# Access Compliance Report

## Public Rights-of-Way

Intersection ID: 47281	Main Street: SAVANNAH_HILLS_DR	Cross Street: CANDLEWOOD_RIDGE_LN	Location: SW
ADA ID: 139E896B8263	Ramp Type: Perp	Initial Pass/Fail: Fail	Overall Compliance: No
Severity Score: 10			
Codes/Mitigation Info/Possible Solution		Field Measurements/Component Compliance

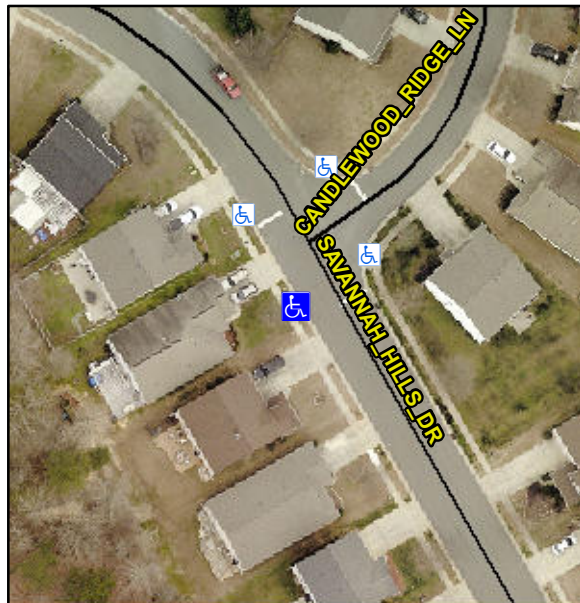
**Not Found, R304.5.1**

Compliance	Description	Data	Compliance	Description	Data
N/A	Ramp Length (in)	47.5	Yes	Ramp Slope (%)	6.4
No	Ramp Width (in)	41.0	Yes	Ramp XSlope (%)	2.5
N/A	Flare Type LT	N/A	N/A	Flare Type RT	N/A
N/A	Flare Slope LT (%)	N/A	N/A	Flare Slope RT (%)	N/A
N/A	Flare Traversable LT?	N/A	N/A	Flare Traversable RT?	N/A
N/A	Landing Length (in)	N/A	N/A	DWS Provided?	N/A
N/A	Landing Width (in)	N/A	N/A	DWS Contrast?	N/A
N/A	Landing Slope (%)	N/A	N/A	DWS Length (in)	N/A
N/A	Landing X Slope (%)	N/A	N/A	DWS Full Width?	N/A
N/A	Landing Curb? (Y/N)	N/A	N/A	DWS Offset (in)	N/A
N/A	Shared Landing?	N/A			
N/A	Gutter Ponding?	N/A	N/A	Gutter Slope (%)	N/A
N/A	Gutter Lip Ht (in)	N/A	N/A	Gutter X Slope (%)	N/A
N/A	Painted X Walk1?	No	N/A	Painted X Walk2?	N/A
	X Walk 1 Direction	To E		X Walk 2 Direction	N/A
N/A	X Walk 1 Width (in)	N/A	N/A	X Walk 2 Width (in)	N/A
	X Walk 1 Slope (%)	6.3		X Walk 2 Slope (%)	N/A
	X Walk 1 X Slope (%)	2.7		X Walk 2 X Slope (%)	N/A

**Remove & Replace Entire Ramp.**
